STAFF RECOMMENDATION
105 South 11th Street
December 16, 2015

Application: New construction - infill
District: Lockeland Springs-East End Neighborhood Conservation Zoning Overlay
Council District: 06
Map and Parcel Number: 08309018100
Applicant: Preston Quirk, Architect
Project Lead: Sean Alexander, sean.alexander@nashville.gov

<p>Description of Project: The application is to construct two buildings on a vacant lot in the Five Points area of the Lockeland Springs-East End Neighborhood Conservation Zoning Overlay.</p> <p>Recommendation Summary: Staff recommends approval of the proposed infill with the conditions that:</p> <ul style="list-style-type: none">• The topography be verified so that the height of the two-story front façade is limited to thirty feet (30') and the third story is limited to forty-five feet (45') tall;• The storefront frieze is wood or fiber cement;• The window, and door selections are approved by MHZC Staff prior to purchase;• The front façade be brick and that all masonry and metal be approved by MHZC Staff prior to purchase;• An eighteen inch (18") to thirty-six inch (36") brick, wood, or fiber cement bulkhead be added below the storefront windows; and• The

SITE PLAN

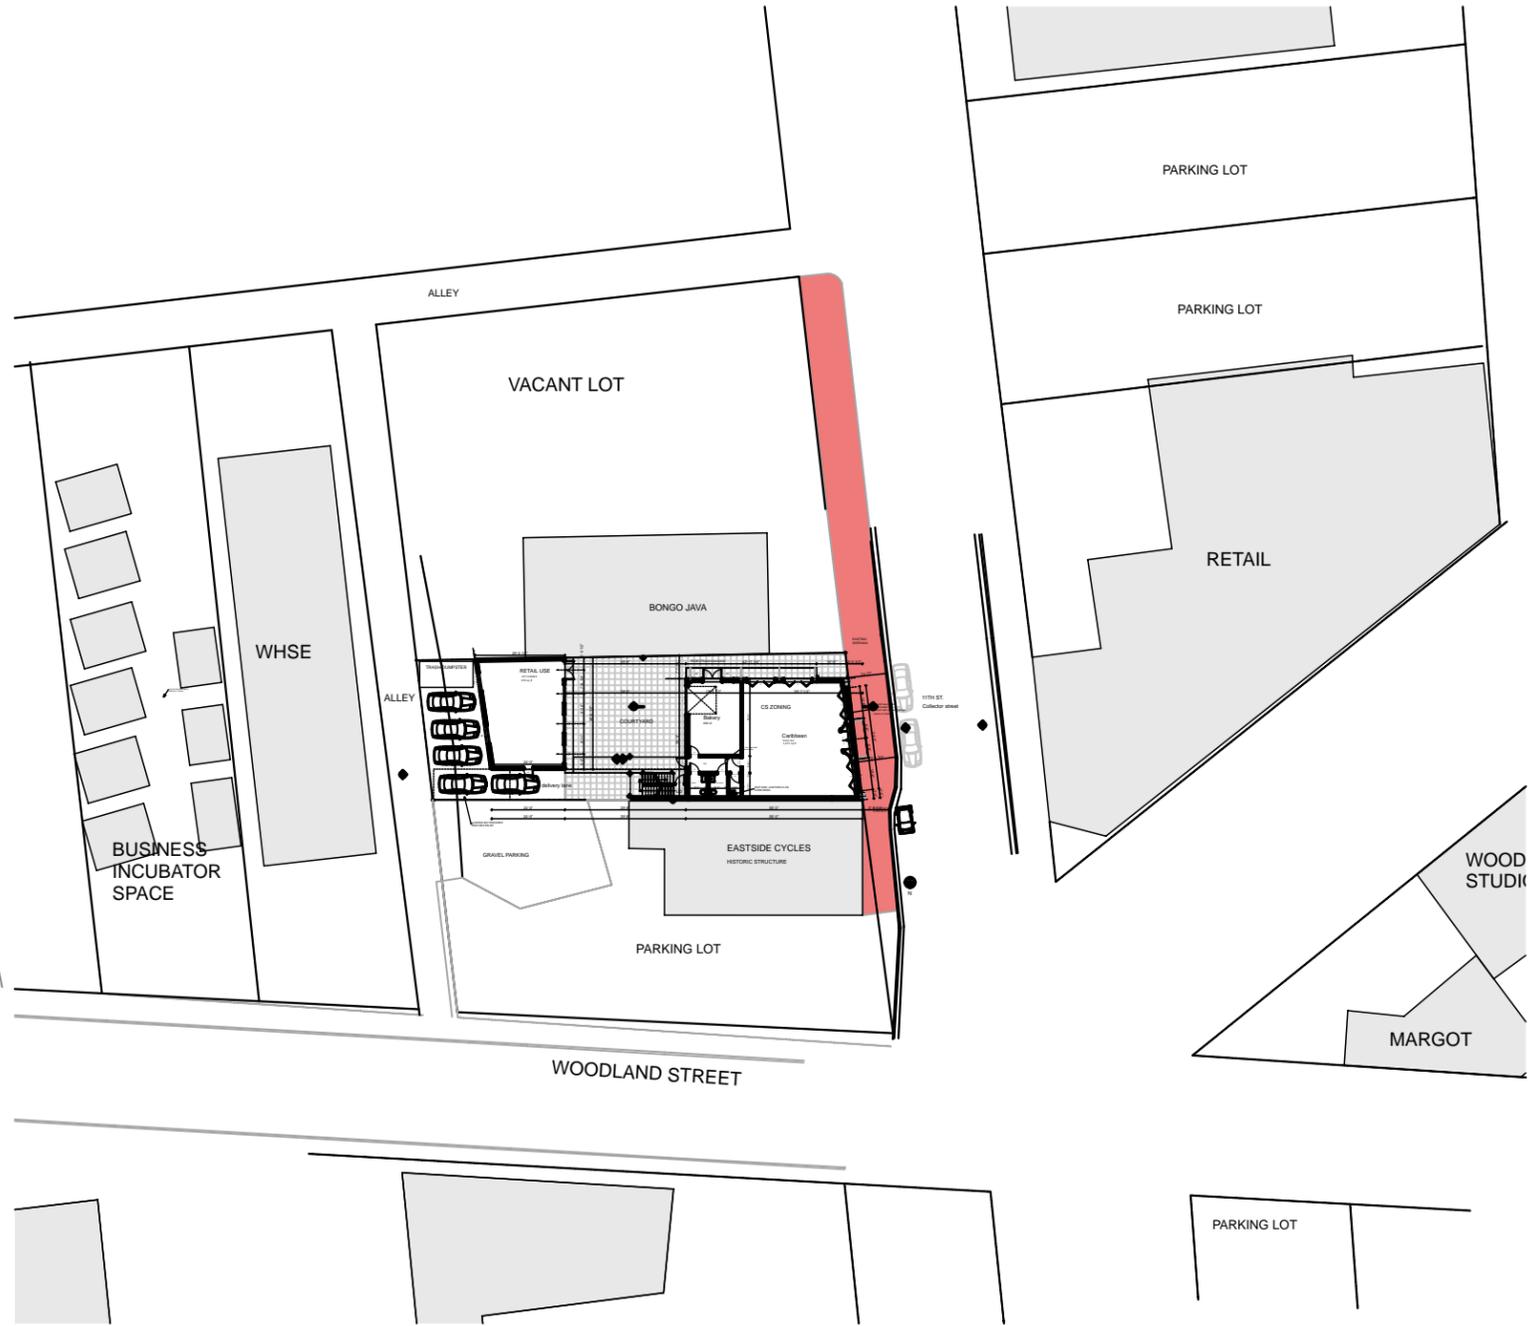
Although the submitted plans show the lot as being flat, staff observed that the lot actually rises one foot (1') north-to-south and falls four feet (4') east-to-west. Staff asks as a condition of approval that the applicant verify the topography and, if necessary, reduce the height of the building accordingly to be no taller than thirty feet (30') and forty-five (45') feet as described previously.

The primary building will abut the historic building to the left, spanning across forty feet (40') of the fifty foot (50') wide lot, leaving a ten foot (10') wide outdoor seating area on the right side. This location is appropriate for a commercial building. The front of the primary building will match the orientation of the adjacent historic building to the left, fronting South 11th Street directly.

The rear building will be constructed at the rear of the lot, twenty feet (20') from the rear of the property line and ten feet (10') from the left, which meets bulk standards. The rear setback and massing is also appropriate for this CS zoned property because it backs up to MUL zoned properties, rather than residential. The front and rear buildings will be forty feet (40') apart, but will be connected by an uncovered walkway at the second level. Upper level walkways have been approved in the past if they are in minimally visible locations. In this case it will not likely be visible from South 11th Street and its visibility from Woodland Street, will likely be obscured by a new building at 101 South 11th Street, at some point.

The plans do not indicate locations of HVAC and utility connections. Staff recommends that they be on the rear or behind the mid-point of the building on a non-street-facing façade. Meeting this condition, Staff finds that the proposal will meet section II.B.9 of the design guidelines.

- The topography be verified so that the height of the two-story front façade is limited to thirty feet (30') and the third story is limited to forty-five feet (45') tall;
- The storefront frieze is wood or fiber cement;
- The window, and door selections are approved by MHZC Staff prior to purchase;
- The front façade be brick and that all masonry and metal be approved by MHZC Staff prior to purchase;
- An eighteen inch (18") to thirty-six inch (36") wood or fiber cement bulkhead be added below the storefront windows; and
- The HVAC and utility connections are at the rear or behind the midpoint on a non-street-facing façade.

ELEVATIONS 1

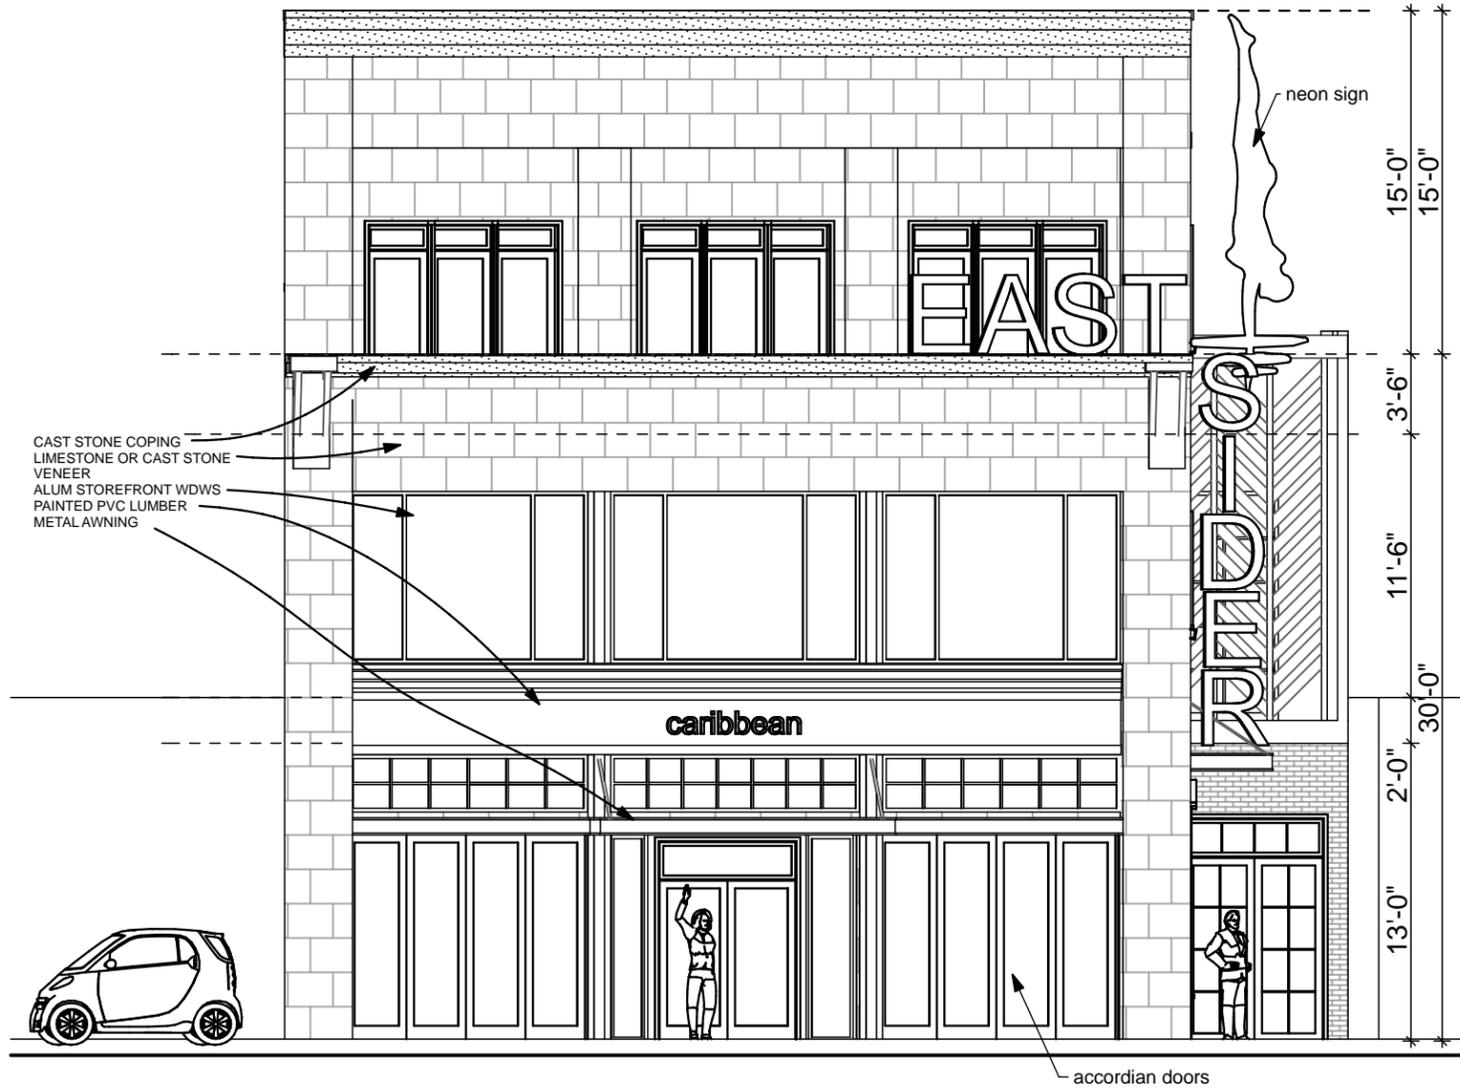
The front building will primarily be brick, with the front façade clad with a cast-stone veneer. The rear building will also be brick, with a decorative metal screen wall on the front of the second story. Staff recommends that the front of the building be clad in brick, to be in keeping with the historic buildings in Five Points. The metal screen wall is

The storefront on this building will have aluminum accordion-style windows with a PVC cornice or frieze above. PVC is not an appropriate material for the storefront frieze, so Staff recommends that the frieze be made of wood or a fiber cement panel. Staff recommends the addition of a bulkhead (see “proportion and rhythm of openings” analysis), which could also be brick, wood, or fiber cement.

The front building will have three-bayed storefront with aluminum accordion-style windows with a rhythm similar to historic commercial buildings nearby. However, the windows extend to the floor whereas historic storefronts would typically have a bulkhead below the windows. Staff recommends that an eighteen inch (18”) to thirty-six (36”) bulkhead be added. The second story will have a row of three three-part windows, which are appropriate for commercial buildings’ upperstories. The third story, set back ten feet (10’) from the front façade, will also have three bays of accordion doors. The right side of the building will have regularly spaced doors and windows, but there will be no openings in the left side of the building.

ELEVATIONS 2

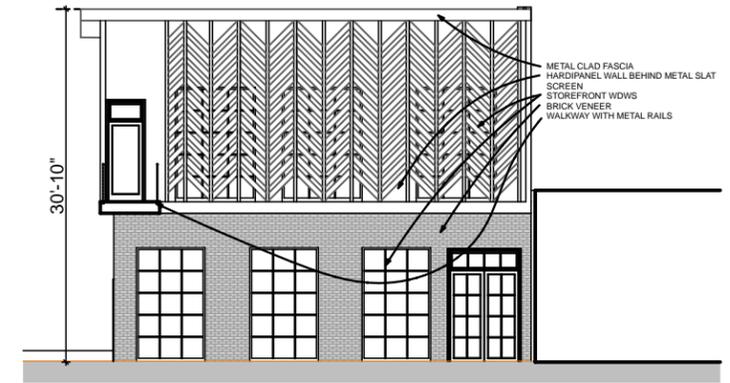
Similarly, the back building will have no windows on the right side that sits directly on the property line. The front of this building will have large windows and doors divided into small squares, somewhat similar to factory or warehouse windows.
